Re: Vista Del Norte, DRB 98-78

***RE: Grading and Drainage Certification Plan for Los Prados Del Norte Subdivision
(D16/D8) Submitted for Release of Financial Guarantees, Engineer's Certification
Stamp Dated 4/26/00.***

RE: *Drainage Report and Grading and Drainage Plan for Los Prados Del Norte Subdivision (D16/D8) Submitted for Preliminary Plat Approval and Grading Permit Approval, Engineer's Stamp Dated 3/5/99.*

SUMMARY OF HYDRAULIC CALCULATIONS CLOSED CONDUIT 2/22/99

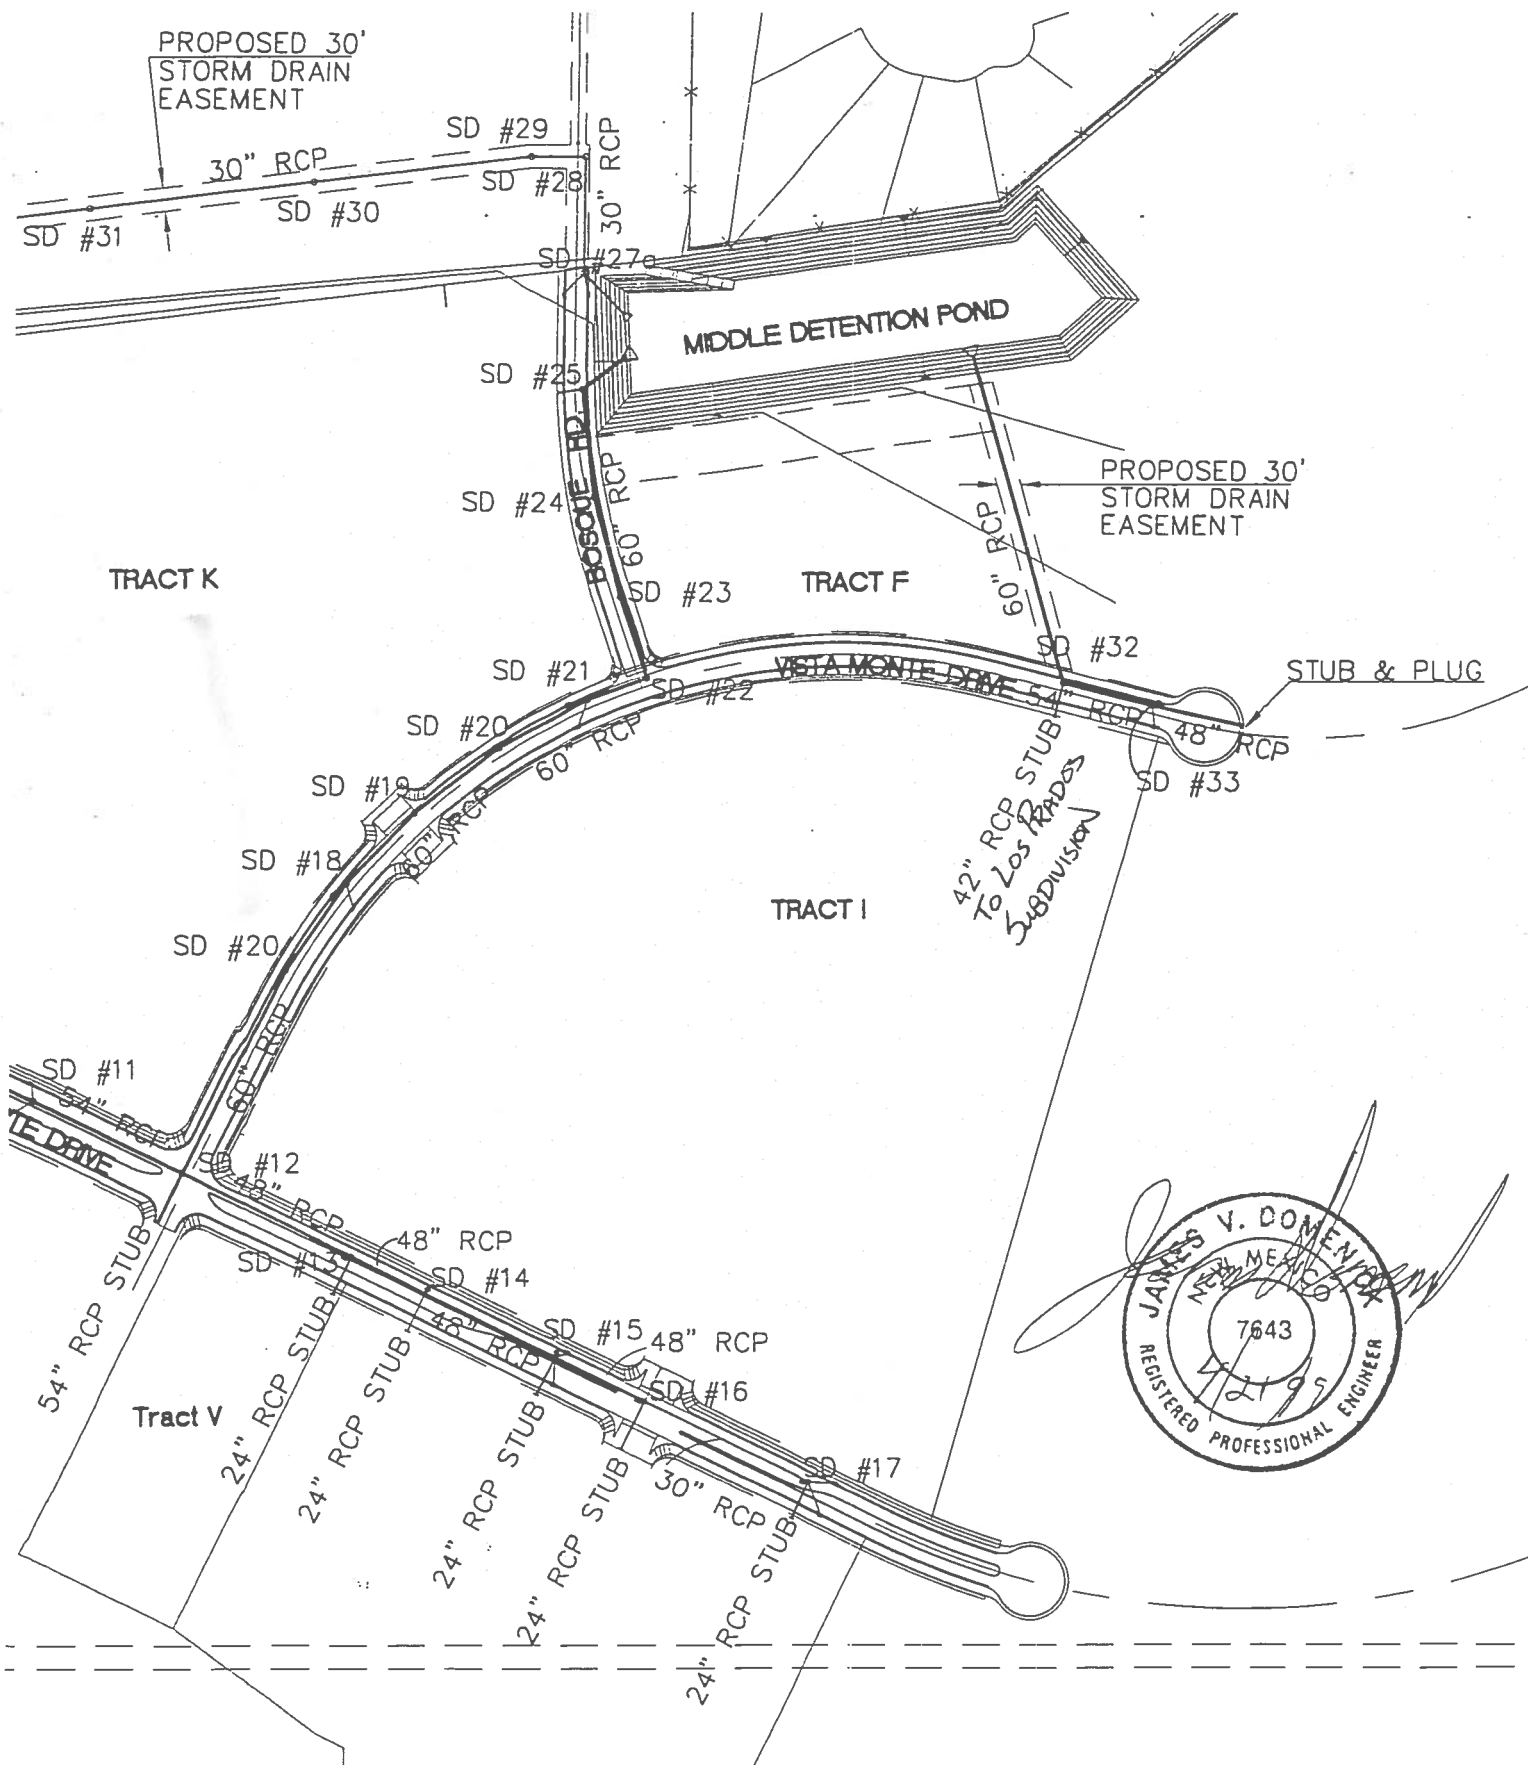
Attached please find the revised Hydraulic Grade Line calculation sheets and a display showing the manhole locations and numbers in relation to the properties being developed by Mark Goodwin and Associates. The outfall for Tract I, Los Prados Del Norte Subdivision, has been relocated from manhole #19 to manhole #32, see display. The other change reflected in the revision is the addition of three additional stubs to Tract W, Villa Del Valle Subdivision. Originally, one stub collected flows from Tract W. At the request of Mark Goodwin's office we added stubs at locations that worked for their design and sized the stubs to handle their flows. No additional flows were added nor removed from this segment. These changes will be reflected in a revised grading and drainage submittal to your office.

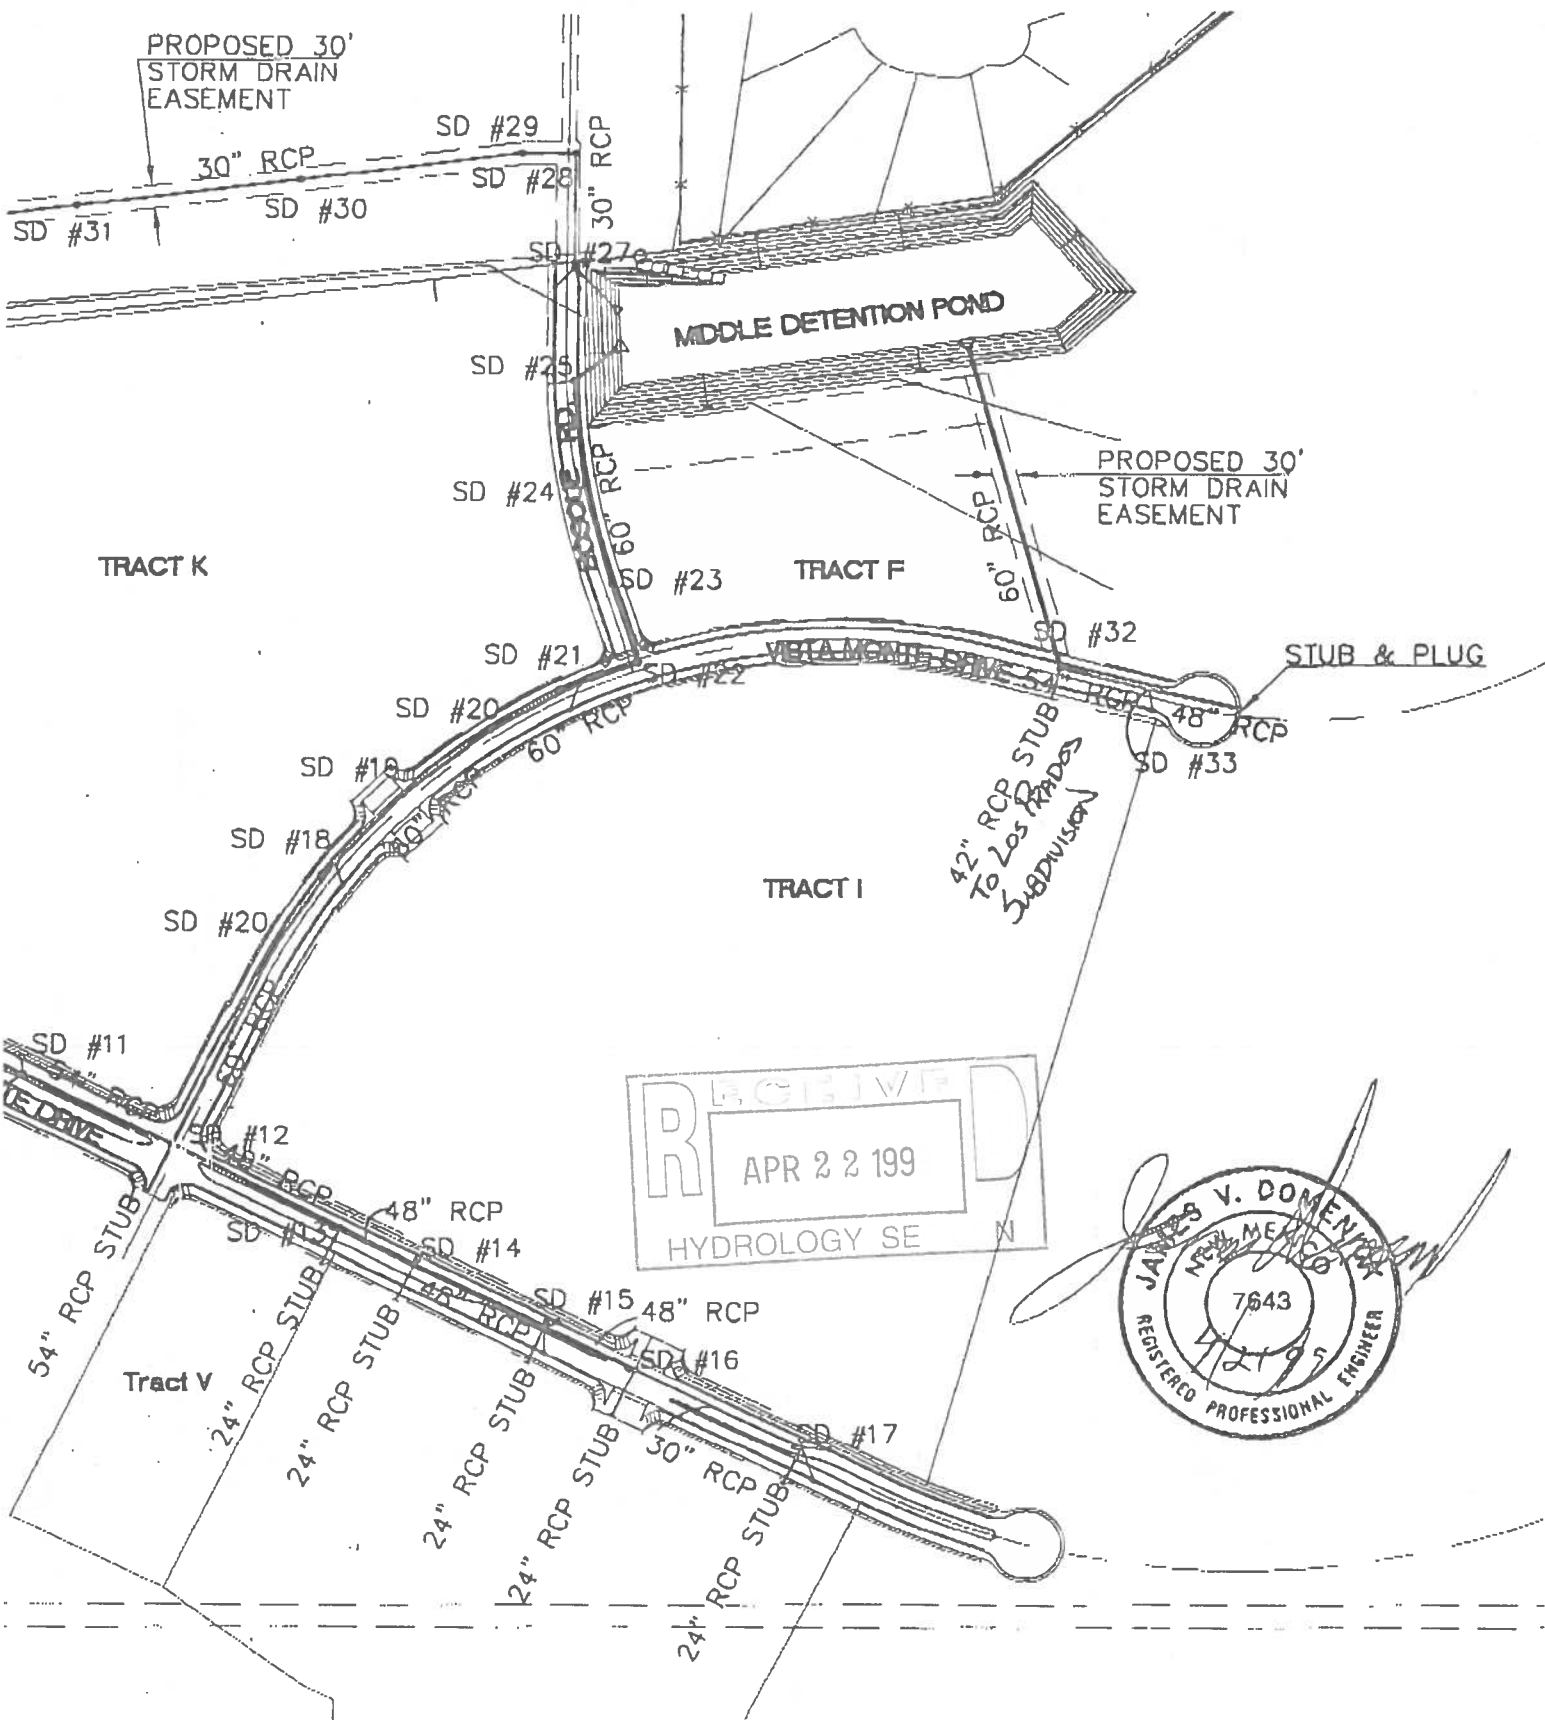
Attached please find the revised Hydraulic Grade Line calculation sheets and a display showing the manhole locations and numbers in relation to the properties being developed by Mark Goodwin and Associates. The outfall for Tract I, Los Prados Del Norte Subdivision, has been relocated from manhole #19 to manhole #32, see display. The other change reflected in the revision is the addition of three additional stubs to Tract W, Villa Del Valle Subdivision. Originally, one stub collected flows from Tract W. At the request of Mark Goodwin's office we added stubs at locations that worked for their design and sized the stubs to handle their flows. No additional flows were added nor removed from this segment. These changes will be reflected in a revised grading and drainage submittal to your office.
